Rack Inspection Report

[REDACTED]
[REDACTED] Facility
[REDACTED]

Section A

Storage room by northern shipping & receiving docks.

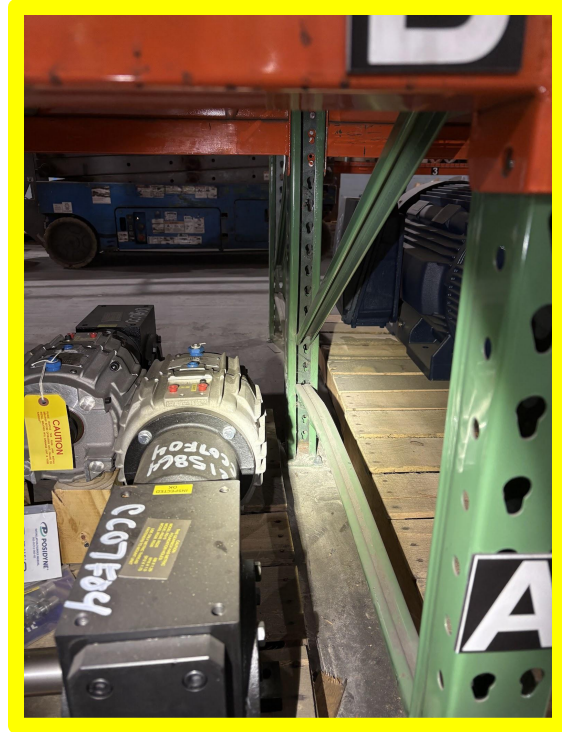
Row 1CB, Bay 1
Beam deflection (Greater than 1/180 beam length) from overloading ¹

Row 1CB, Bay 1
Damaged Horizontal Brace ²

Row 1CB, Bay 5
Damaged Horizontal Brace ²

Row 1CB, Bay 5
Upright Missing Anchors ⁴

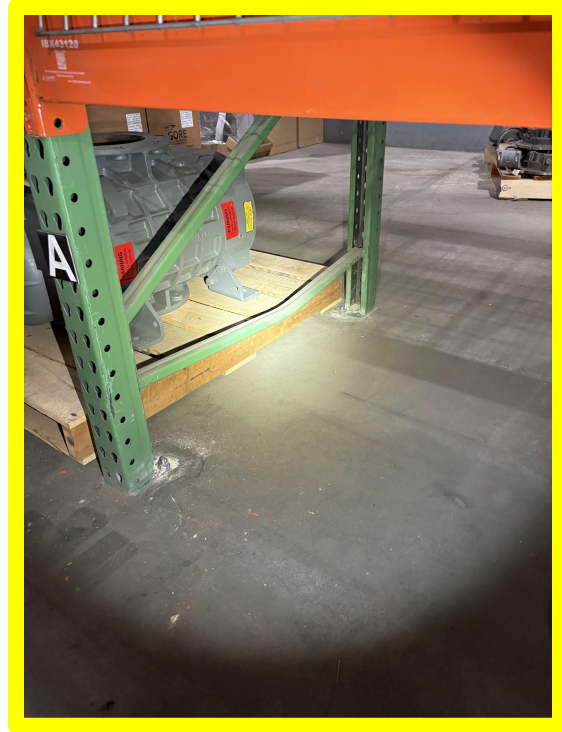
Rows 1CC & 1CB
Longitudinal flue space less than 3"
minimum between rows (NFPA 13) ⁸

1CC, Bay 5
Upright Missing Anchors ⁴

1CC, Bay 4
Upright Missing Anchors ⁴

1CC, Bay 4
Damaged Beam ³
